**Architectural Review Committee Meeting – Follow-up  
February 28, 2024**

**4:00 p.m. Sandy City Fire Station 31 Replacement project (9295 South Monroe Street), Heber Slabbert, Trevon Beutler (AJC Architects), Jeffrey Bassett, Sandy City Fire Chief, Ryan McConaghie, Sandy City Deputy Fire Chief**

### **Compass Mixed Use project (157 West 9270 South), Nick Lazarev, Cole Peterson (Boyer Group), David Denison (Gardner Group), Ioanna Magiati, Jose Ho (AO Architects)**

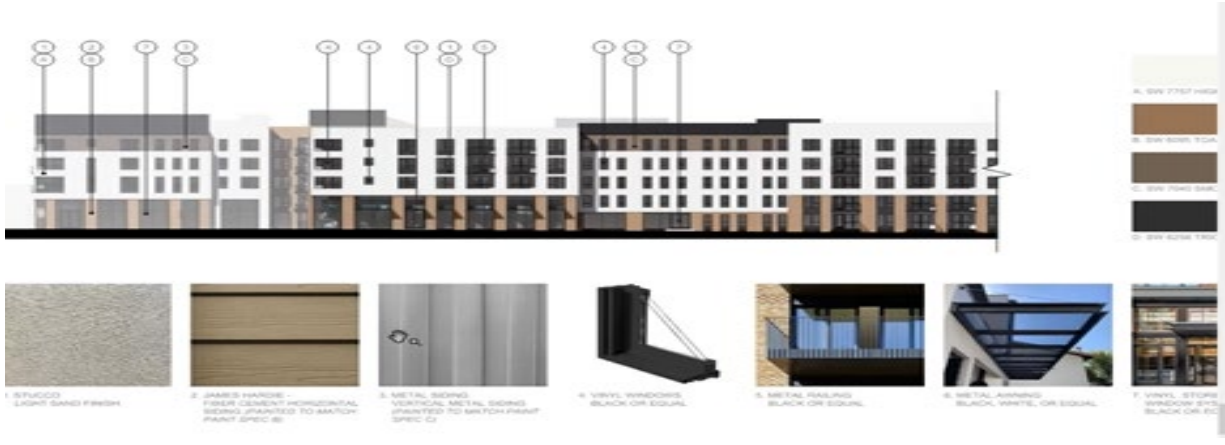
Steve asked as far as the Plaza, are they saying that the Plaza has not been designed and is it just a placeholder.

Steve would like to see design plans that show the Plaza having spaces for outdoor seating for the public.

Nick said this is a landscape architectural perspective and is very schematic. Because of this, they would love comments on specific things that would help to enhance the master plan.

Nick stated that in the future, they will show a rendering of a fully programmed Plaza.
